DART AEROSPACE LTD	Work Order:	119707
Description: Crosstube Assembly (205/212 High Aft)	Part Number:	D212-664-241
Inspection Dwg: D212-664-241 Rev: D		Page 1 of 2

DRAWING NO. D212-664-241	TITLE CROSSTUBE ASSY (205/212 HI AFT)	REV. D	DART AEROSPACE LTD ENGINEERING ORDER		D.E.O. NO. D212-664-241-D-1	SHEET NO. SHEET 1 OF 2	SCALE NTS
DRAWN	CHECKED	MFG. APPR.	APPROVED	DE APPR.			
DATE 11.04.07	DATE 11.04.11	DATE 11.04.12	DATE 11/04/12	DATE 11.04.12

DRAWING NO. D212-664-241	TITLE CROSSTUBE ASS'Y (205/212 HI AFT)	REV. D	DART AEROSPACE LTD ENGINEERING ORDER		D.E.O. NO. D212-664-241-D-2	SHEET NO. SHEET 1 OF 1	SCALE NTS
DRAWN <i>q</i>	CHECKED <i>ASS</i>	MFG. APPR. <i>DS</i>	APPROVED <i>MD</i>		DE APPR. <i>MD</i>		
DATE 11.07.15	DATE 11.07.20	DATE 11.07.21	DATE 11/27/21		DATE 11.07.21

**D212-664-241/-241B
ASSEMBLY DETAIL**

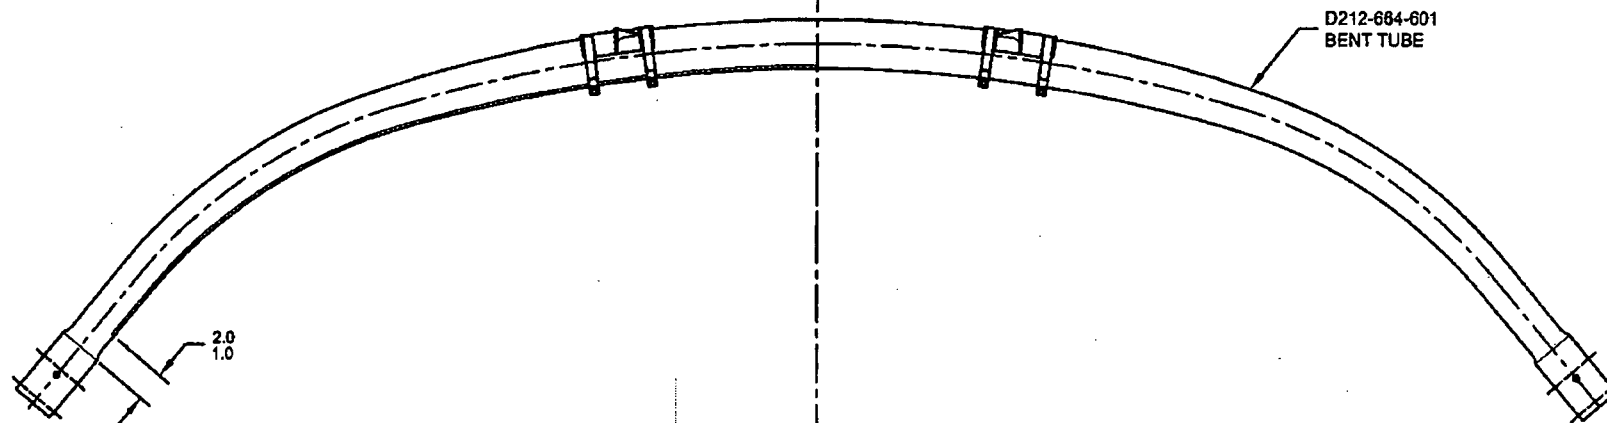
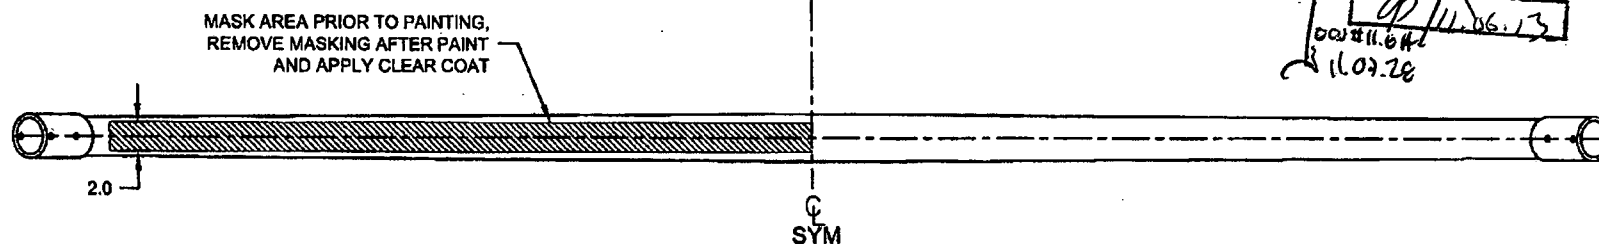
PURPOSE:

ADD AN INSPECTION WINDOW TO UNDERSIDE OF CROSSTUBE.

NOTES 2 OF SHEET 1 IS AMENDED AS FOLLOWS:

- 2) FINISH: CHEMICAL CONVERSION COAT PER DART QSI 005 4.1
PRIME INSIDE AND OUTSIDE PER DART QSI 005 4.2
MASK UNDERSIDE OF CROSSTUBE AS SHOWN (HATCHED AREA) AND
PAINT OUTSIDE PER DART QSI 005 4.2
REMOVE MASKING AND APPLY CLEAR COAT

- 2) FINISH: CHEMICAL CONVERSION COAT PER DART QSI 005 4.1
PRIME INSIDE AND OUTSIDE PER DART QSI 005 4.2
PAINT OUTSIDE PER DART QSI 005 4.2
